Pilot Region-Based Optimization Program for Fund-Lead Sites in EPA Region 3

Site Optimization Tracker: Crossley Farm Superfund Site Hereford and Washington Townships Berks County, Pennsylvania

**Streamlined
Optimization Evaluation Report**

**Crossley Farm Superfund Site
Hereford and Washington Townships
Berks County, Pennsylvania**

Figure 1: Conceptual Location Recommended for Extraction Wells

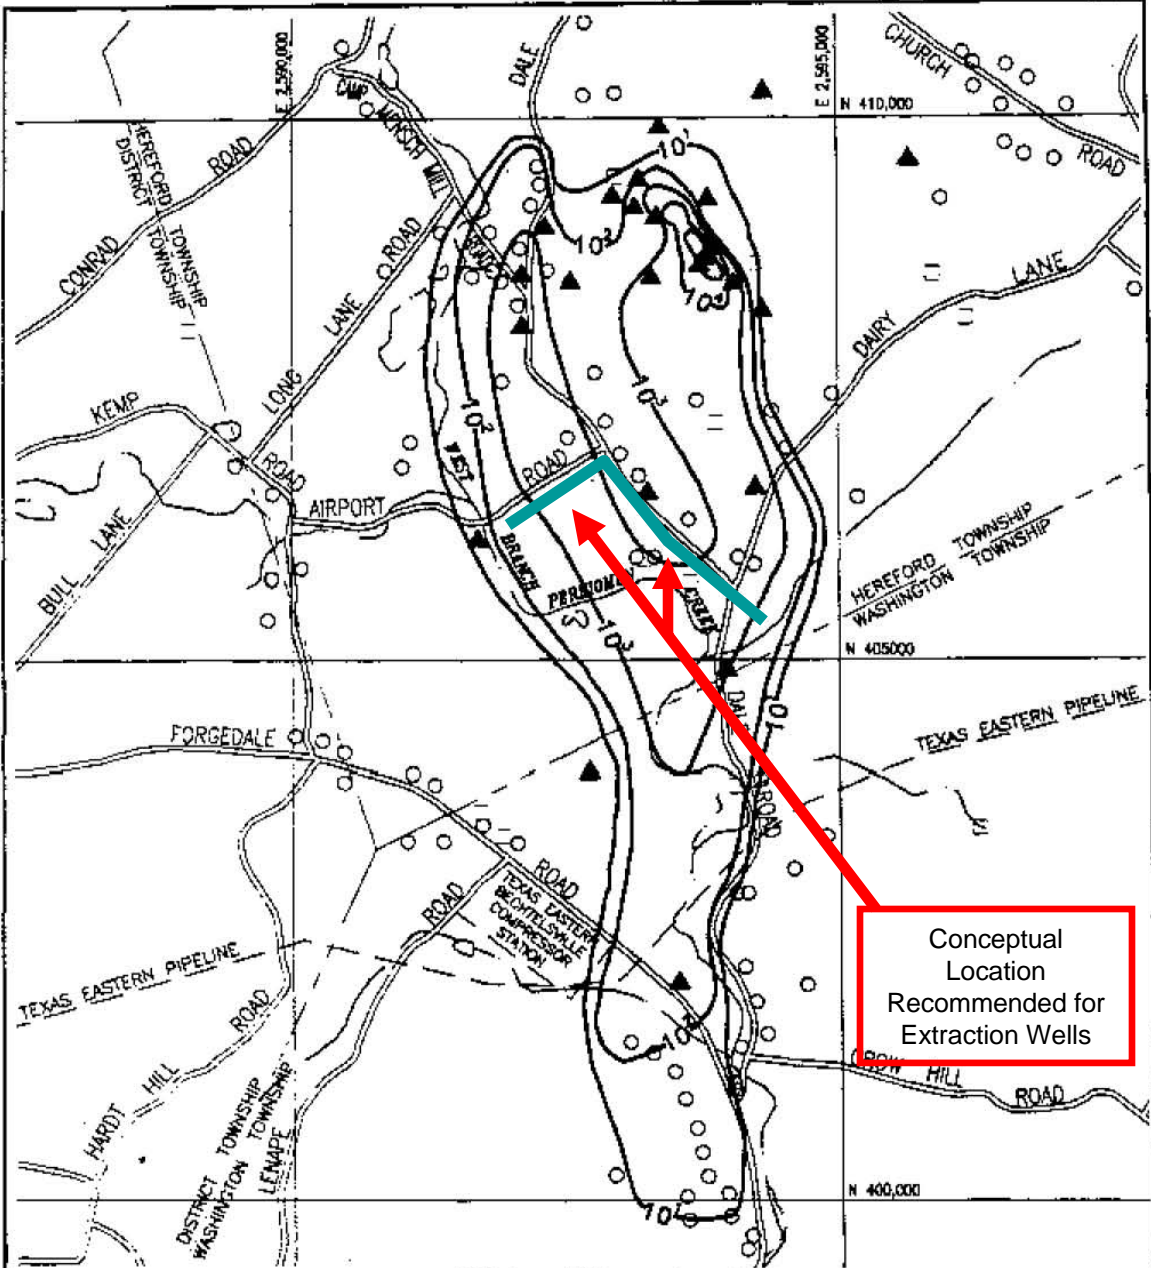
The optimization team believes that the active treatment of the 100,000 ug/l TCE plume near the borrow pit area, which is the planned interim remedy as per the ROD/ESD for OU2, should not be the initial focus of an interim or final remedy. Instead, the optimization team initially recommended that the initial focus should be on designing and installing ground water extraction wells and a ground water treatment plant (air stripping with discharge to surface water) further downgradient. This was discussed with the site team during a meeting on July 20, 2005, and after further discussions with the site team during the site visit on September 14, 2005, there appeared to be agreement that this approach had merit.

Based on discussions during the site visit, there appeared to be consensus that extraction wells could be located along Airport Road (between the West Branch of Perkiomen Creek and Dale Road), and along Dale Road between Airport Road and Dairy Lane (perhaps extending just east of Dairy Lane). This is illustrated on Figure 1. This is downgradient of the borrow pit area (the extraction location associated with the ROD/ESD for OU2), but more upgradient than the extraction area originally suggested by the optimization team. A treatment plant could be built in the vicinity of the intersection of Airport Road and Dale Road, with discharge of treated water to the West Branch of Perkiomen Creek.
